Amendments to the Drawings:

SERIAL NO.: 09/997,133
PETER H. PRIEST (919-942-1434)

FIG. 2N

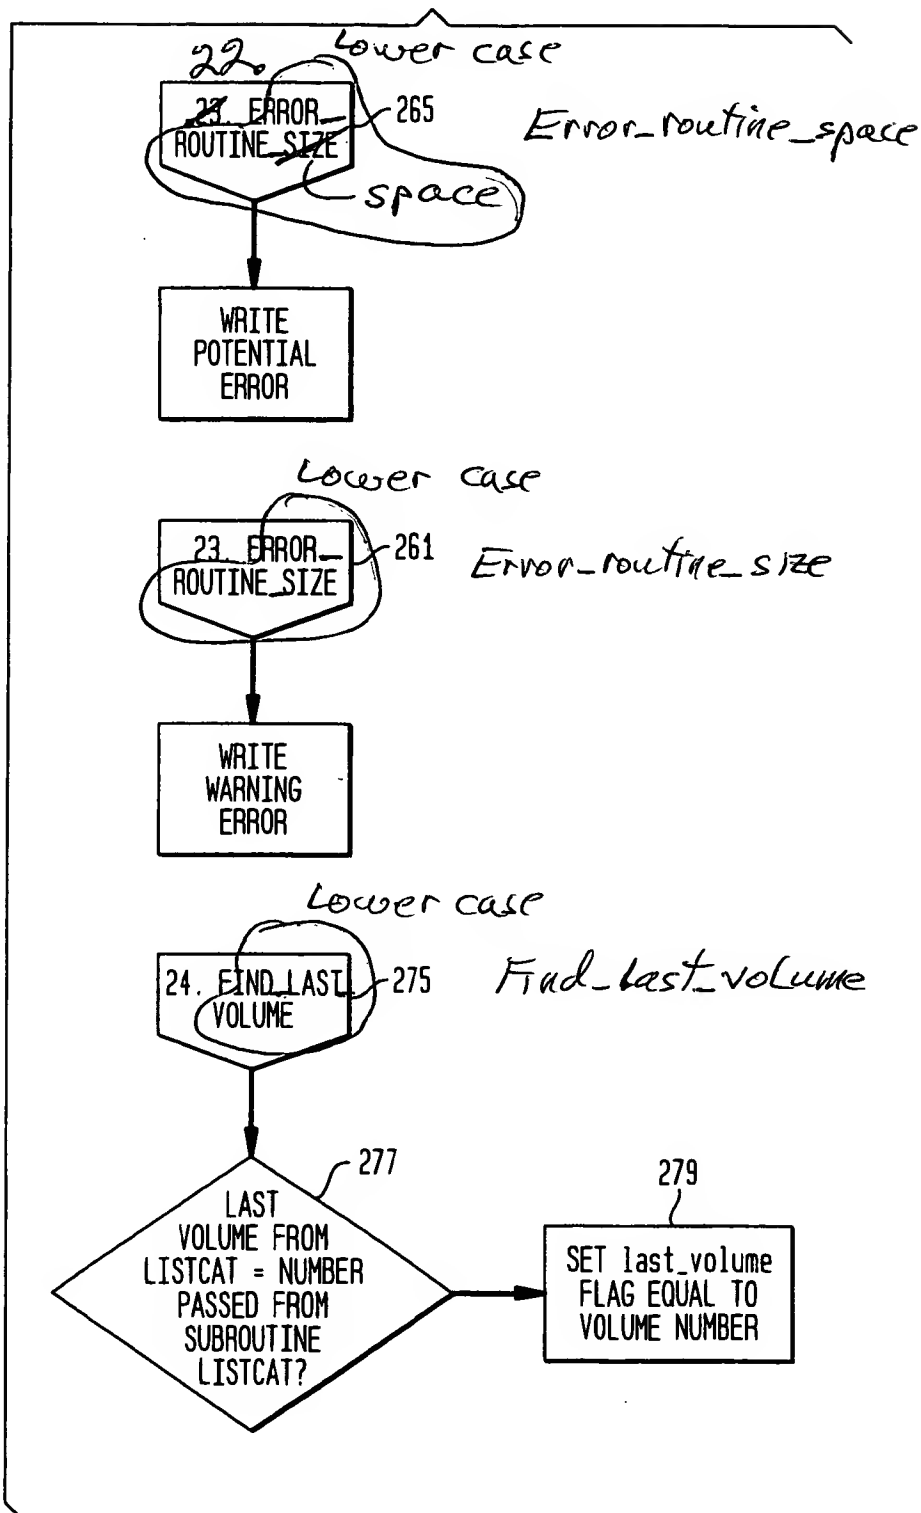
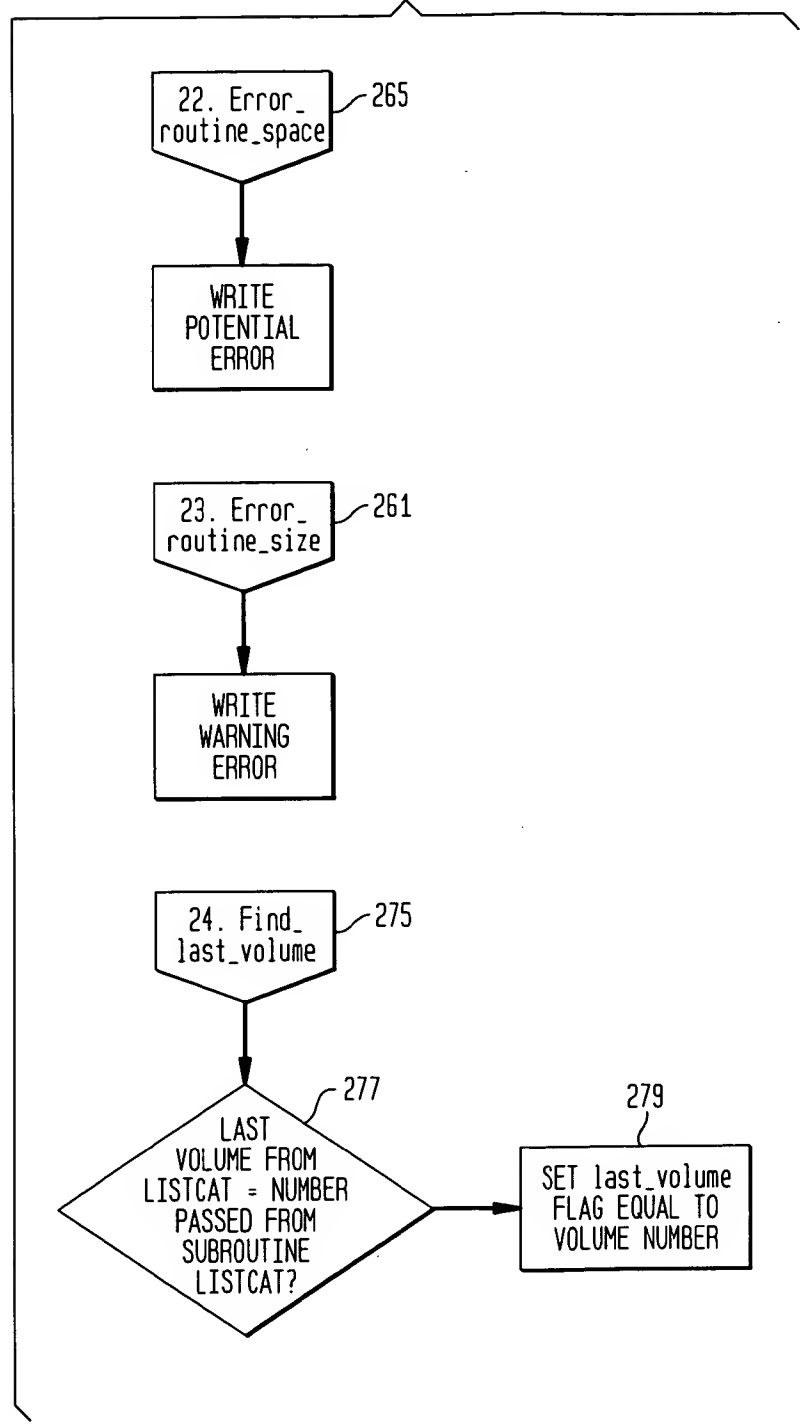
In Fig. 2N, the legend "23. ERROR ROUTINE SIZE" on block 265 is corrected to "22. Error_routine_space" to correct a duplicate number in the legends of blocks 265 and 261, an incorrect name, and be consistent with the capitalization and name reference used in the specification, for example, error_routine_space step 265 page 13, lines 7-8, and drawing Fig. 2M 22. Error_routine_space block 265. The legend "23. ERROR ROUTINE SIZE" on block 261 is corrected to "23. Error_routine_size" to be consistent with the capitalization and name reference used in the specification and other drawings. Also, the legend "FIND LAST VOLUME" on block 275 is corrected to "24. Find_last_volume" to be consistent with the capitalization and name reference used in the specification.

FIG. 20

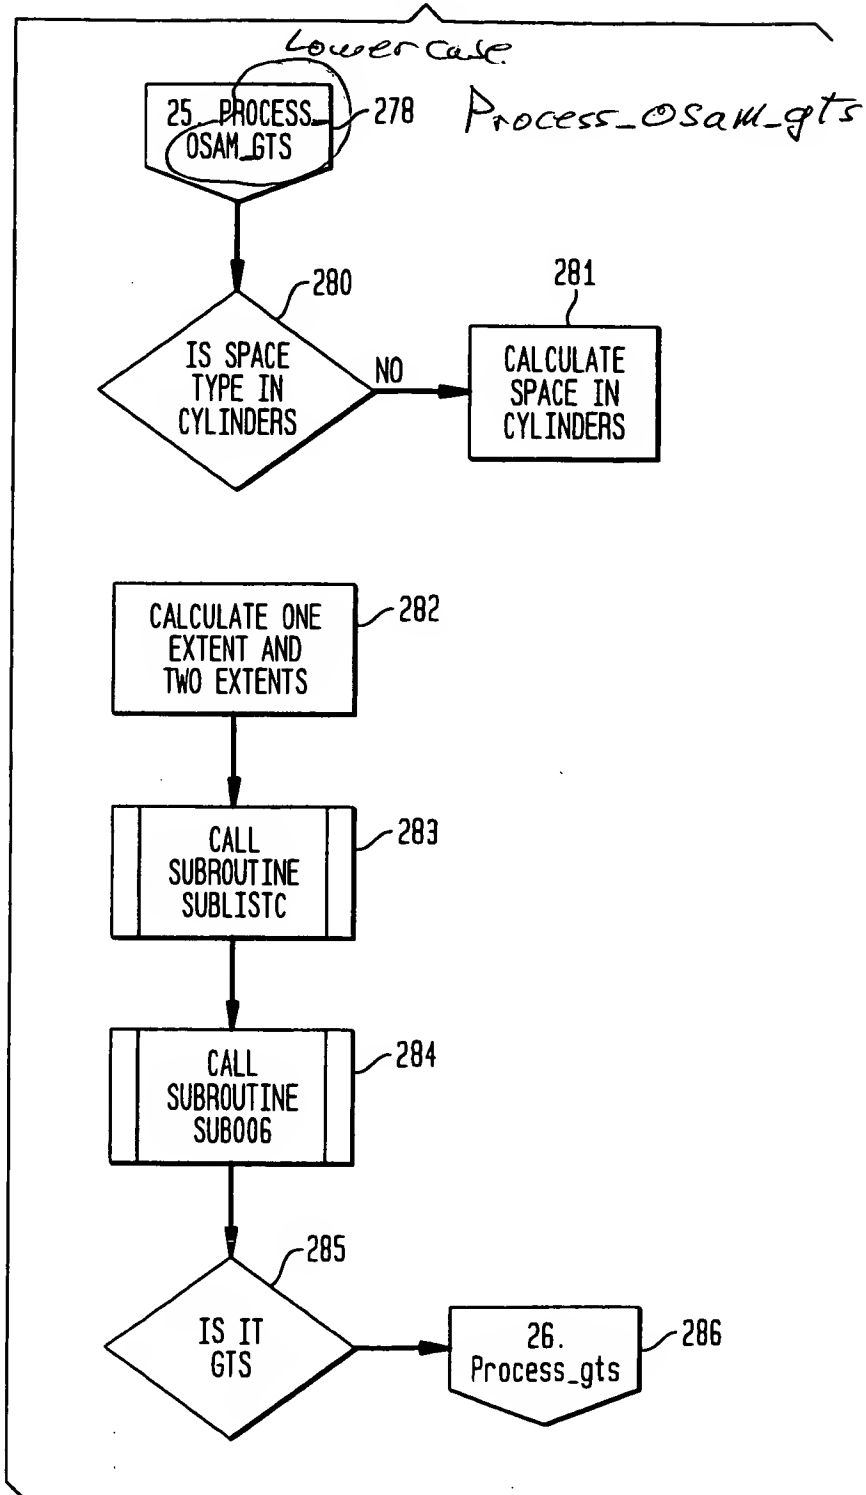
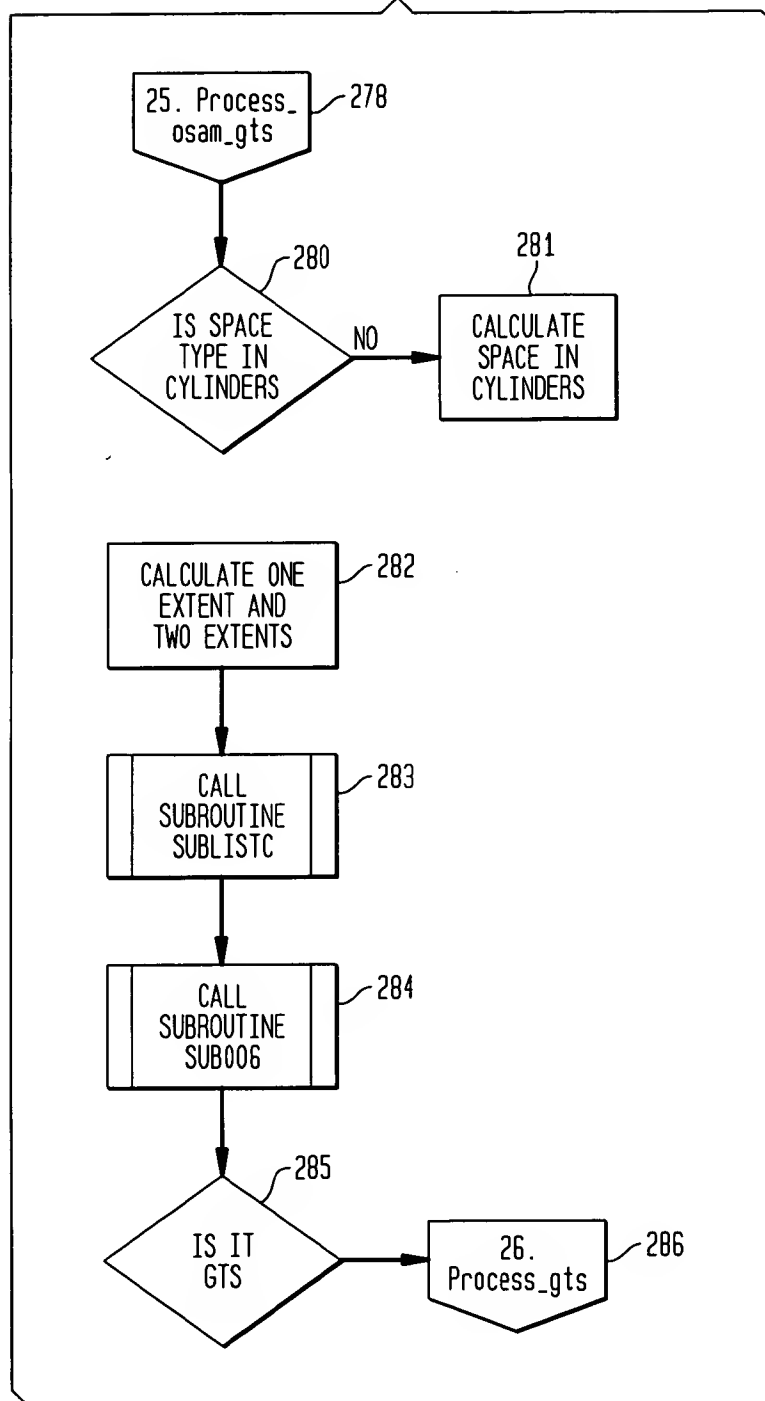
In Fig. 2O, the legend "25. PROCESS OSAM GTS" on block 278 is corrected to "25. Process_osam_gts" to be consistent with the capitalization and name reference used in the specification.

FIG. 2R

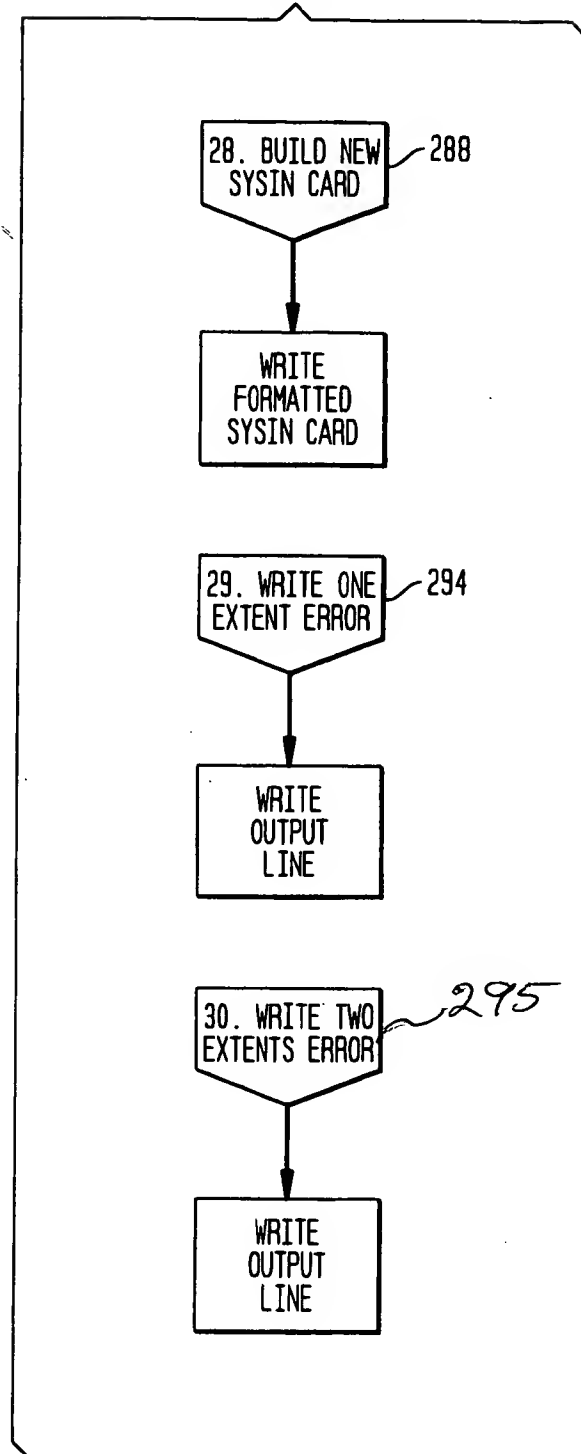
In Fig. 2R, the block with legend "30. WRITE TWO EXTENTS ERROR" is corrected to add the missing reference number 295.
